ABS MWO FIELD SERVICE BULLETIN

Several M939/A1/A2 series trucks have been found with improper installation of the M939 ABS MWO 9-2320-272-35-1. These instructions contain a method for inspection of the vehicles to identify whether the air supply hose installation is not correct and procedures to correct the installation.

FIGURE 4. INCORRECT (VIEWED FROM TOP)

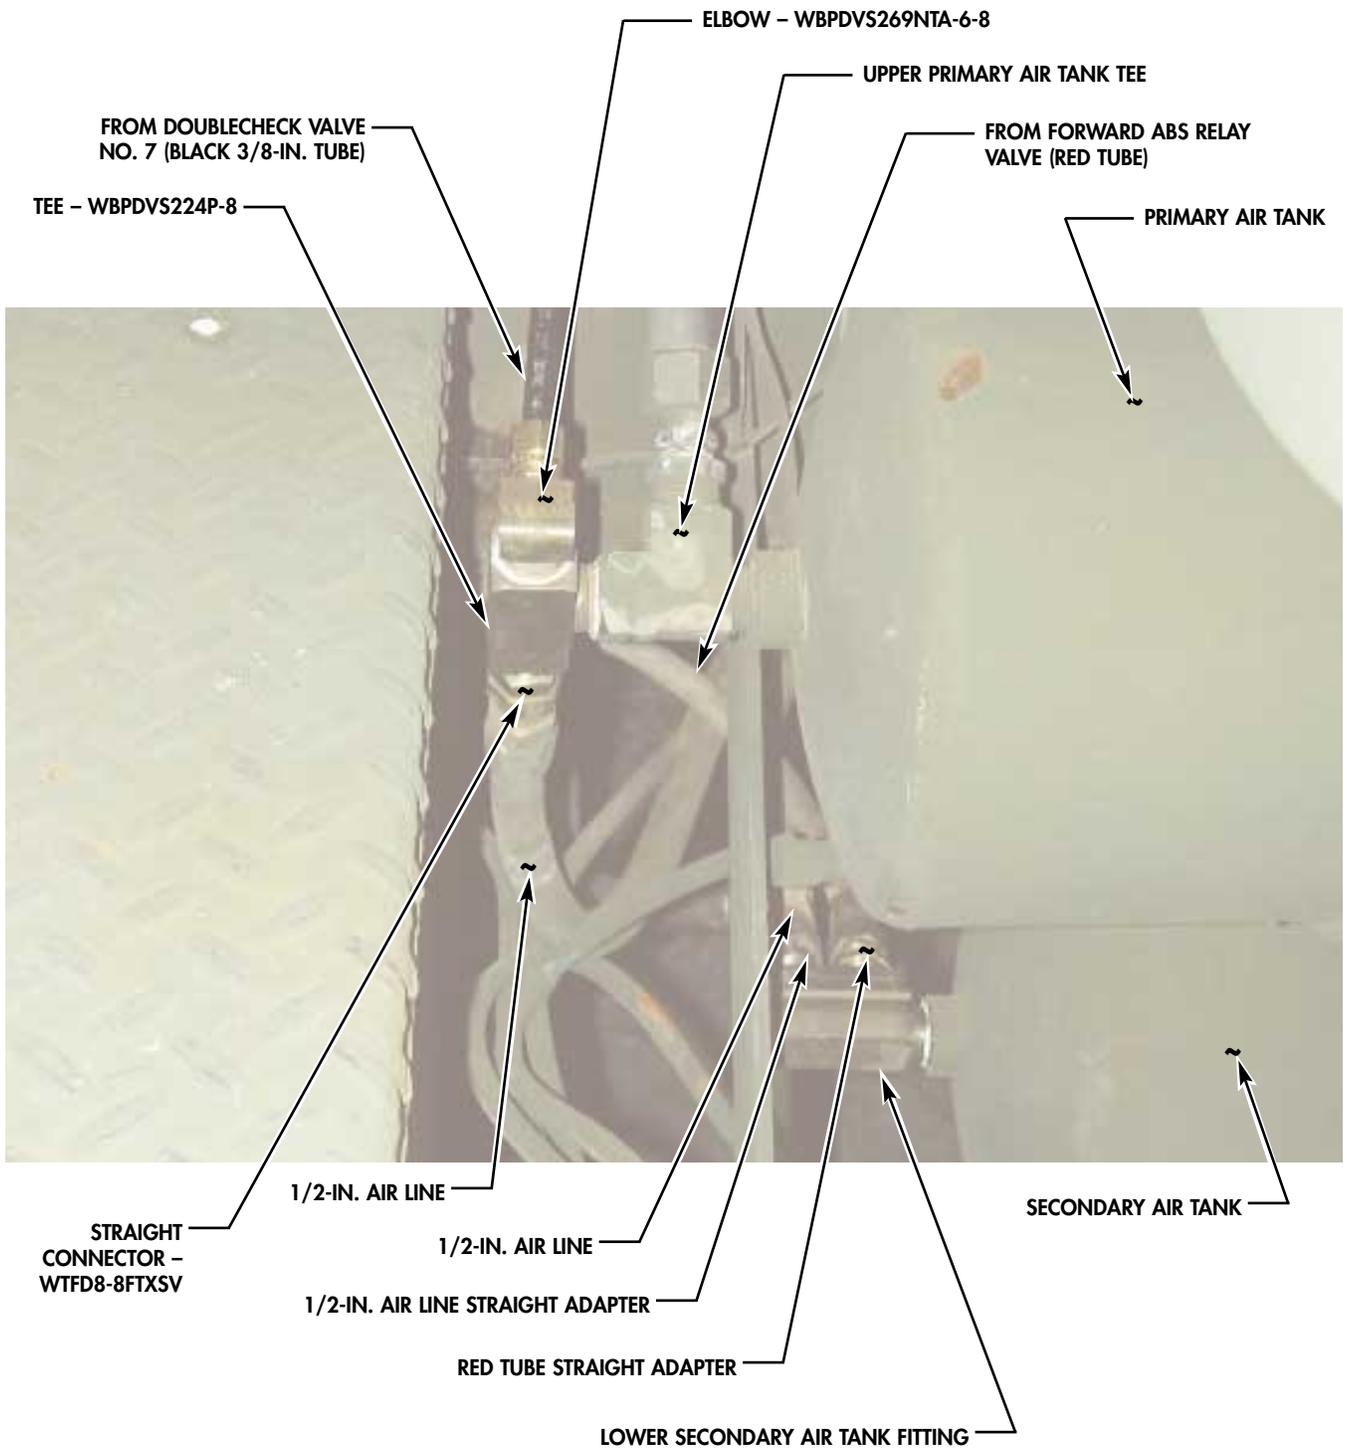
(3) If red and black tubes are in correct locations (figures 1, 2, and 3), no further action is required. If red and black tubes are not in correct position (figure 4), proceed to disassembly.

- a. Drain all air reservoirs.
- b. Disconnect red tube and remove red tube straight adapter from lower secondary air tank fitting (figure 4). Discard adapter.
- c. Disconnect 1/2-in. air line and remove 1/2-in. air line straight adapter from lower secondary air tank fitting (figure 4). Retain adapter.
- d. Disconnect black 3/8-in. tube and 1/2-in. air line from primary air tank tee (figure 4).
- e. Remove tee WBPDV224P-8 with attached fittings from upper primary air tank tee. Remove elbow WBPDV269NTA-6-8 and straight connector WTFD8-8FTXS from tee (figure 4). Retain elbow, connector, and tee.
